DA RECONSIDERATION AMENDMENT - OCTOBER 2025

PROJECT
17-21 UNIVERSITY AVENUE & 24 MARCUS CLARKE STREET,
CANBERRA, ACT

DRAWING TITLE
BUILDING A SHORT SECTION 1,2 & 3
SCALE
As indicated @ A1
DATE
OCTOBER 2025

DRAWING NUMBER
ADA.09.01

2 BUILDING A SHORT SECTION 2
DA.09.01 1 : 200 @ A1

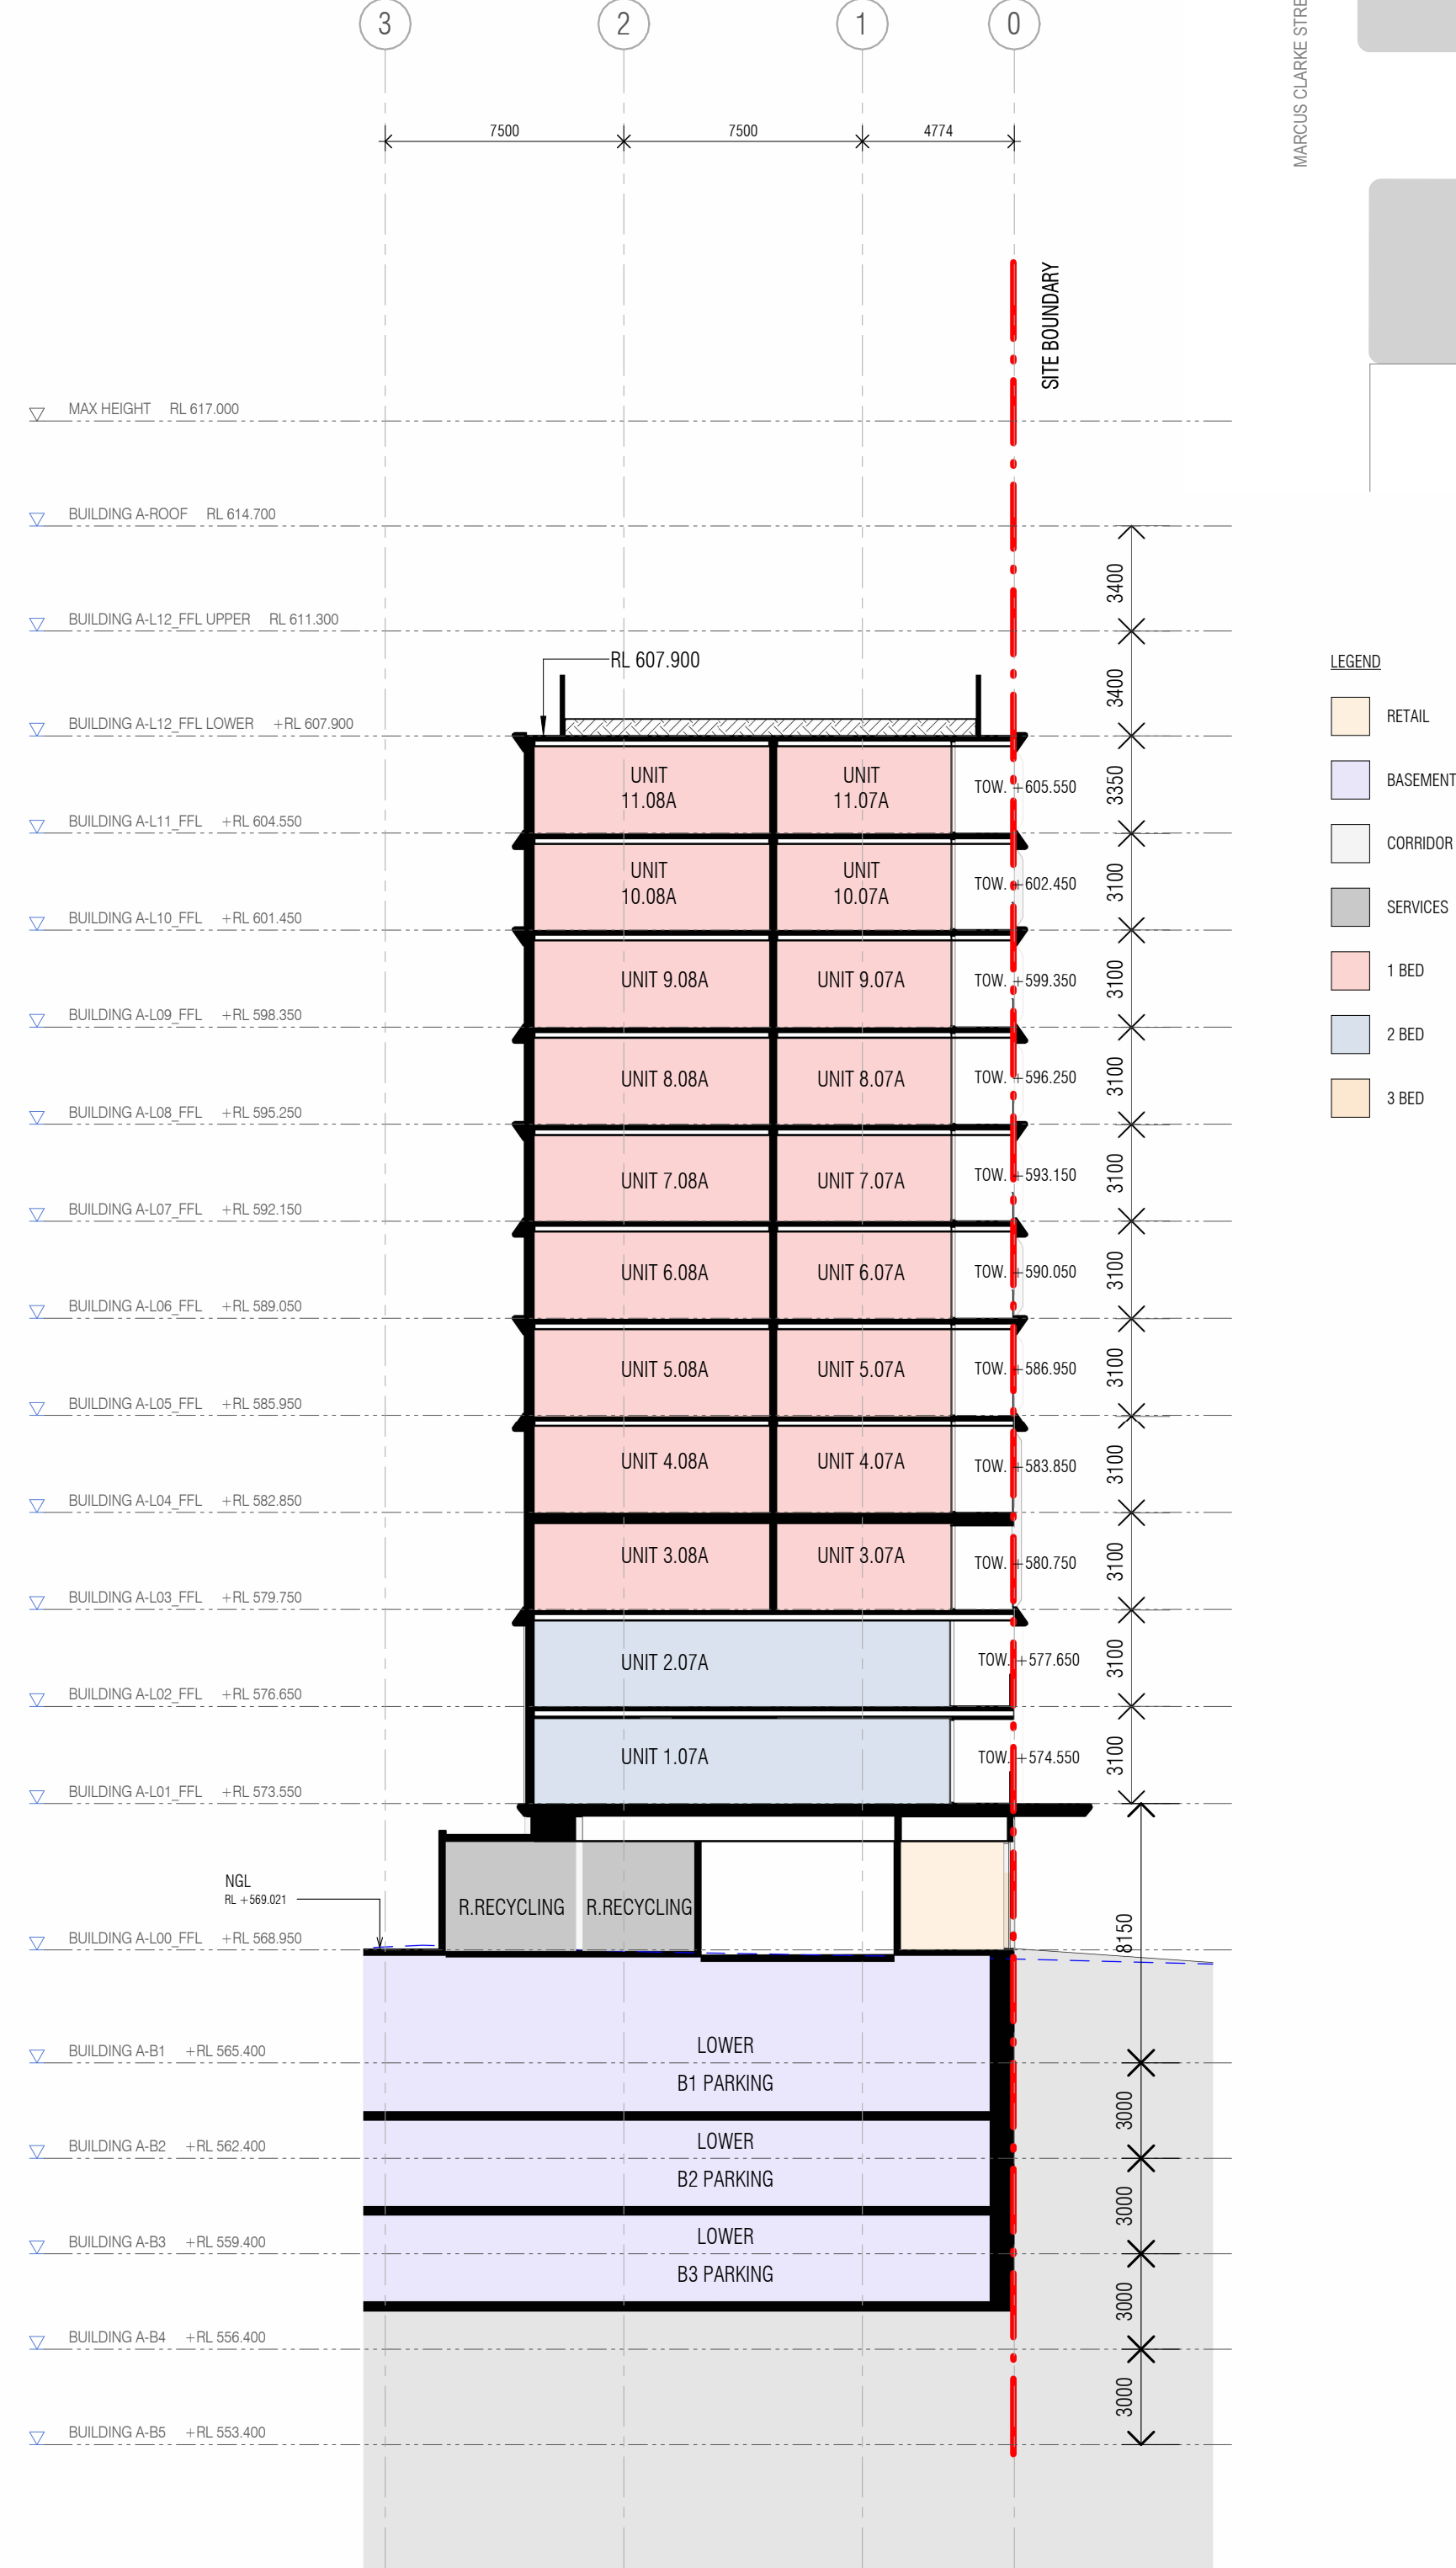
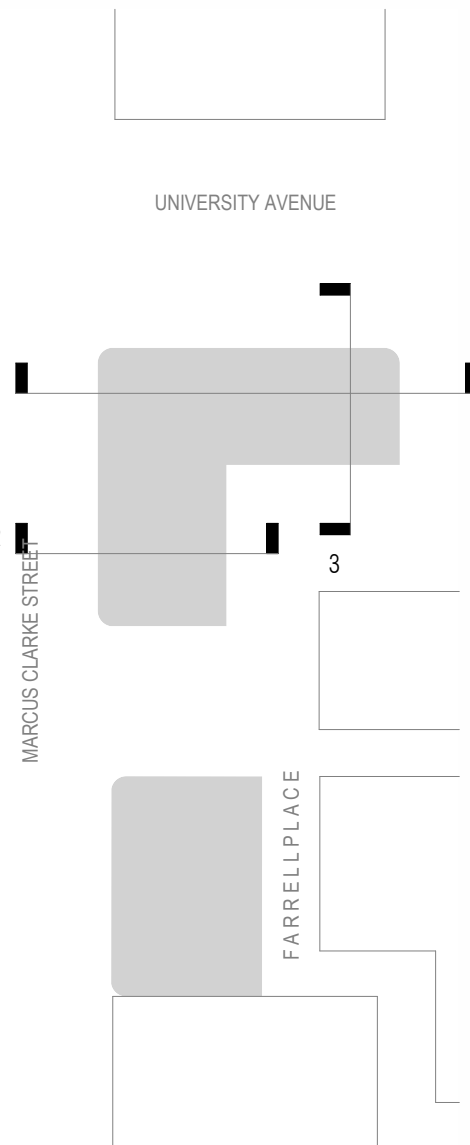
01. UPPER LEVEL CHANGES

- OVERALL HEIGHT OF BUILDING A REDUCED AND BUILDING B INCREASED TO ALIGN WITH AUTHORITY DISCUSSIONS
- COMMON ROOFTOP GARDEN ADDED TO BUILDING A ADDRESSING UNIVERSITY AVENUE
- BUILDING FACADES DESIGN IMPROVEMENTS
- UNIT PLANS UPDATED AND UNIT MIX AMENDED
- RECONFIGURATION OF BUILDING CORE THROUGHOUT THE UPPER LEVELS
- WINTER GARDENS REMOVED AND REPLACED WITH DEDICATED BALCONY SPACES
- UPPER LEVEL ENCROACHMENTS CONTAINING GFA REMOVED FROM UNIVERSITY AVENUE FRONTAGE
- SOLAR ACCESS TO UNITS MAXIMISED AND DEMONSTRATED

02. GROUND FLOOR CHANGES

- AWNING ADDED TO UNIVERSITY AVENUE
- GROUND FLOOR COMMERCIAL LEVELS ADJUSTED TO EXISTING VERGE LEVELS AND REDUCE STAIRS
- LEVELS ADJUSTED IN THE CENTRAL LANDSCAPE SPACE FOR ACCESSIBILITY
- SERVICE LOCATIONS UPDATED TO SUIT SERVICE LOCATIONS
- INCREASE TO LANDSCAPE AREAS
- UPDATE TO WASTE ROOMS WASTE COLLECTION STRATEGY
- ON GRADE PARKING ALONG DARWIN REMOVED AND RELOCATED TO THE UPPER BASEMENT LEVEL

03. BASEMENT LEVEL CHANGES

- EXTENT OF BASEMENT 5 REDUCED WHILST MEETING THE CARPARKING RATES
- RECONFIGURATION OF BUILDING CORE AND RATIONALISATION OF BASEMENT RAMPS
- RECONFIGURATION OF BUILDING SERVICES AS PER ADVICE RECEIVED
- VISITOR PARKING ADDED TO BASEMENT LEVELS, INCLUDING RELOCATION OF EXISTING CARPARKING ON DARWIN PLACE PROPOSED FOR REMOVAL
